Wylfa Newydd Project

Horizon's Responses to IACC's Deadline 3 Submission

PINS Reference Number: EN010007

17 January 2019

Figure 1 – DCO Transport Assessment

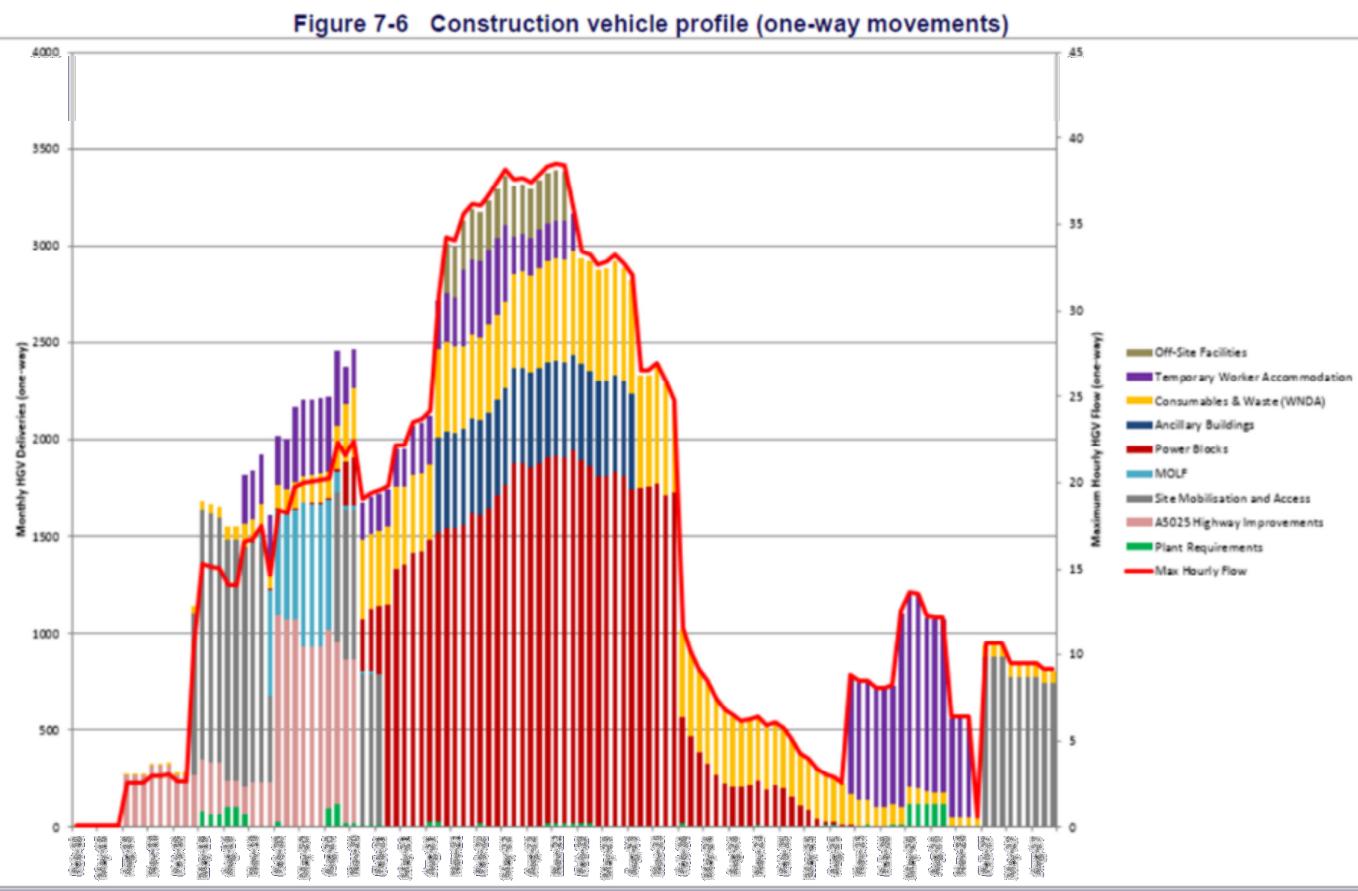
FWQ11.1.10: The traffic modelling/assessment is predicated on the basis that the MOLF will enable delivery of the majority of materials direct to the site. Is there any modelling/contingency that deals with the potential increase in vehicular movements should construction of the MOLF be delayed. In particular would the road network have the capacity to take any additional movements that may result and if there is an increase in movements how would this affect local residents?

Interested Party	IP response to Horizon's Response to FWQ	Horizon Comments
IACC	<p>The principle of assessing the effects as a result of delay to the delivery of key project components is welcomed by the IACC. However, the findings of this assessment does not address concerns raised previously by the IACC. The project control documents must address:-</p> <p>Delay to the delivery of the MOLF resulting in a delay to the commencement of First Nuclear Concrete Unit 1.</p> <p>Control of increase in HGVs in the later months of a delay to the MOLF, given the situation at Hinkley Point C where a 50% increase was needed.</p> <p>Delay to the delivery of the A5025 Off-line Improvements, as well as the cumulative impact of delay to the delivery of both the A5025 improvements and MOLF.</p>	<p>Horizon is committed to providing key mitigation, including the MOLF and the A5025 Off-Line Highway Improvements by fixed dates in the Phasing Strategy, which is a control document, and which has been updated and submitted at Deadline 4 (17 January 2019).</p> <p>Horizon's construction approach is different to that of Hinkley Point C (HPC), it is unlikely that the same situation would occur. Horizon are committed to delivering the MOLF within schedule to meet their construction programme. In the unlikely event there is a delay there is a range of options that Horizon could use which would not require an increase to HGVs.</p> <p>Horizon has made commitments to capping HGV movements within the Wylfa Newydd CoCP, which is a control document and which has been updated and submitted at Deadline 4 (17 January 2019).</p>

The construction of the MOLF will require the delivery of materials by road using Heavy Goods Vehicles (HGVs). The estimated number and profile of these HGV movements along the A5025 is presented in Figure 7-6 of the DCO Transport Assessment.

If the delivery of the MOLF were to be delayed then this would mean that the number of HGVs travelling to the WNDA associated with the construction of the MOLF would be spread over a longer period.

Should the MOLF opening be delayed, any additional construction vehicles bringing materials to the WNDA by road will be managed so as not to exceed the daily cap, as specified in paragraph 5.4.13 of the Wylfa Newydd Code of Construction Practice, of 160 construction vehicle deliveries per day to the WNDA.

Overall, this assessment shows that delaying the delivery of the MOLF by six months does not affect the conclusions of the transport analysis presented in the Draft DCO application.
